Project	IEEE 802.16 Broadband Wireless Access Working Group < http://ieee802.org/16 >	
Title	Problem with the AAS Network Entry	
Date Submitted	2003-03-07	
Source(s)	<p>Tal Kaitz, Naftali Chayat Alvarion</p> <p>Emmanuel Degeest, Marc Engels, Jan Erreygers LoraNet</p> <p>Panyuh Joo, FengMing Cao, ChangHo Suh, Hai Wang Samsung</p>	<p>Voice: +972 54 22 55 48 Fax: +972 3 645 62 04 tal.kaitz@alvarion.com</p> <p>Voice: +32 16 28 16 17 Fax: +32 16 28 86 50 jan.erreygers@imec.be</p> <p>Voice: +86 010 684277112130 Fax: +86 010 68481898 wanghai@samsung.co.kr</p>
Re:	Call for contribution IEEE 802.16d-03/02	
Abstract	This document describes a problem with AAS Network Entry method and proposes a solution for the OFDM PHY mode.	
Purpose	For inclusion in the 802.16d amendment document	
Notice	This document has been prepared to assist IEEE 802.16. It is offered as a basis for discussion and is not binding on the contributing individual(s) or organization(s). The material in this document is subject to change in form and content after further study. The contributor(s) reserve(s) the right to add, amend or withdraw material contained herein.

Problem with the AAS Network Entry

Fig. 4: Single Snapshot of Samples after the cross-correlation
 (a) LP cross-correlation, (b) LTS cross-correlation and (c) AAS suggested cross-correlation.

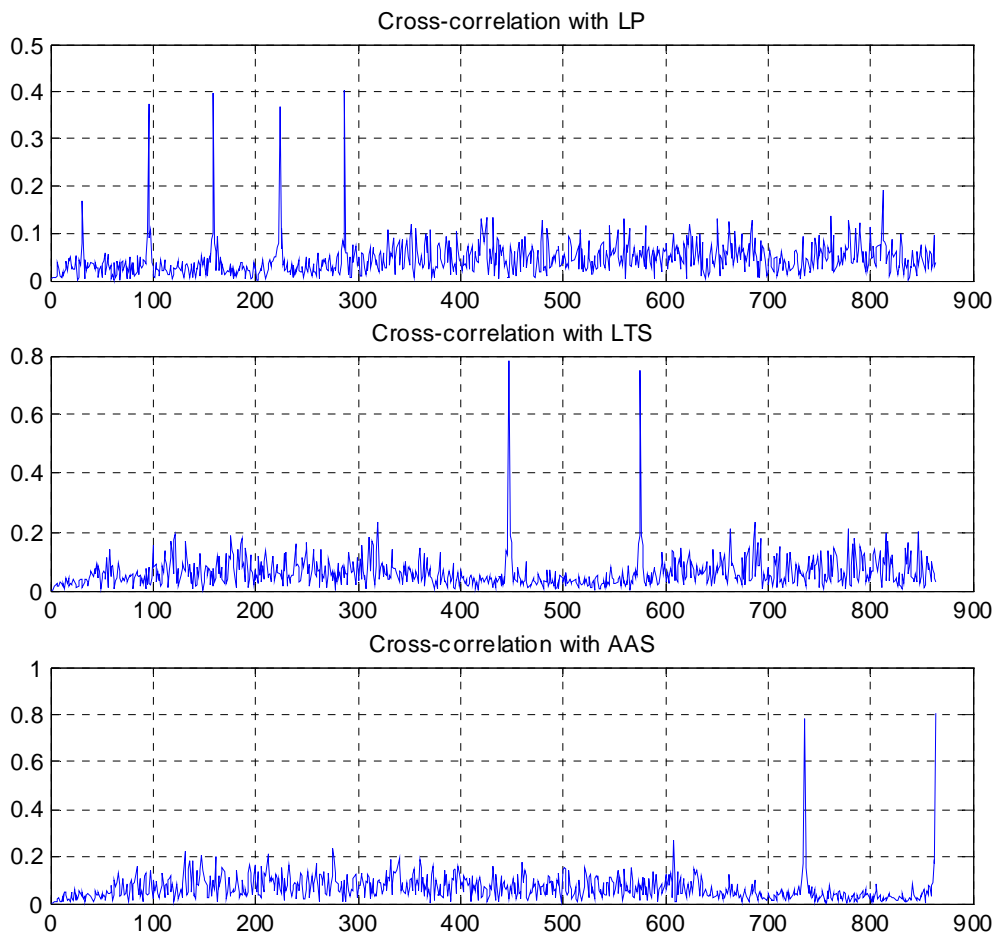
The received signal was cross-correlated with LP, LTS and AAS separately. The cross-correlation windows used for the first symbol of the long preamble (4 times 64 sequence = LP), the data preamble (2 times 128 = LTS), and the suggested AAS network entry preamble (AAS) are respectively 64, 128 and 128.

Fig. 4 shows a snapshot of the obtained samples for each correlation window.

We can see no significant spurious correlation peaks appear for the cross-correlation of different preambles. This visual check is confirmed by computing the relative height of the major spurious correlation peak with respect to the desired correlation peak. Table 1 shows these results.
